Technical Bulletin 209

07.2020

Item: 209.3

Description: Front Fork Tightening Sequence (incorporating Fork Top Caps and Directional Indicators)

Lower Yoke Pinch Bolts Tightening Sequence

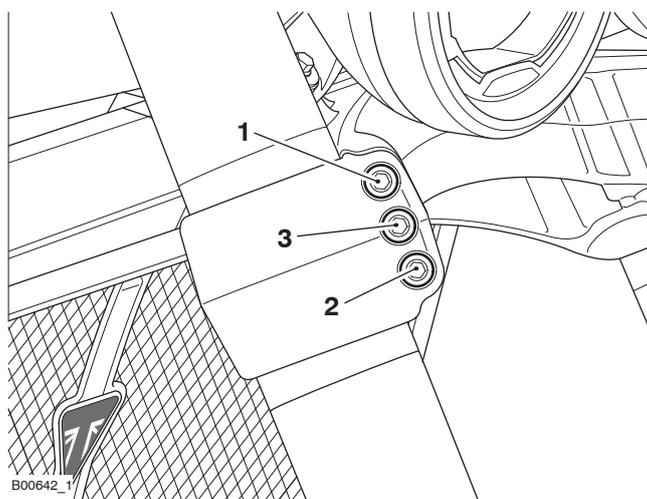
The tightening sequence for the front fork fixings for the above models has changed as described below.

1. Fit new fixings and tighten the pinch bolts in the following three stages:

2. Tighten the fixings in the sequence shown to **25 Nm**.

3. Tighten the fixings in the sequence shown to **25 Nm**.

4. Tighten the fixings in the sequence shown to **25 Nm**.

Upper Yoke Pinch Bolts Tightening Sequence

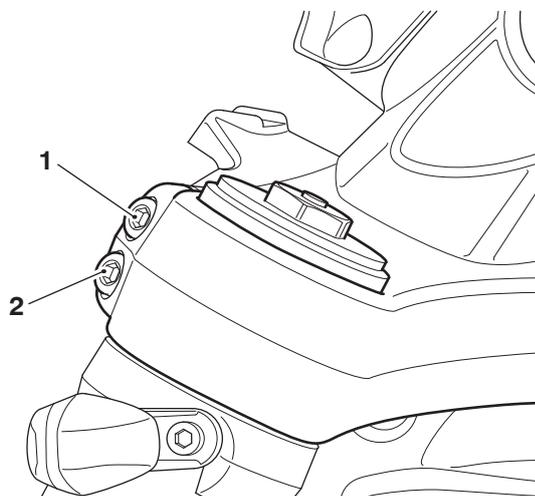
5. If the fork top caps have been loosened, tighten them to **35 Nm**.

6. Tighten the upper yoke pinch bolts in the following two stages:

7. Tighten the fixings in the sequence shown to **25 Nm**.

8. Tighten the upper fixing to **25 Nm**.

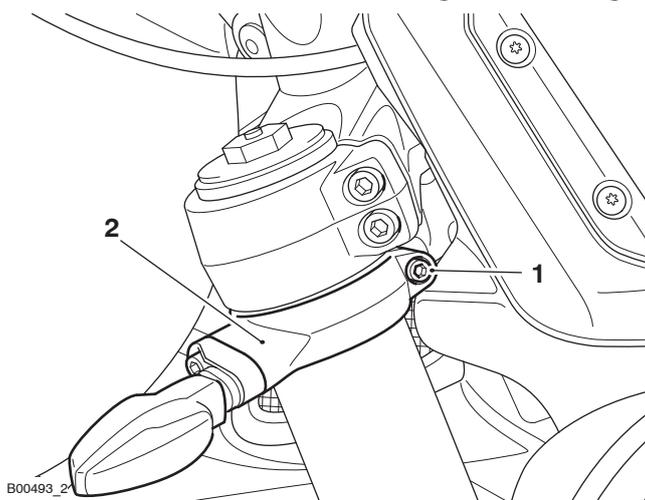
9. Position the direction indicator as noted for removal and tighten its fixing to **3 Nm**.
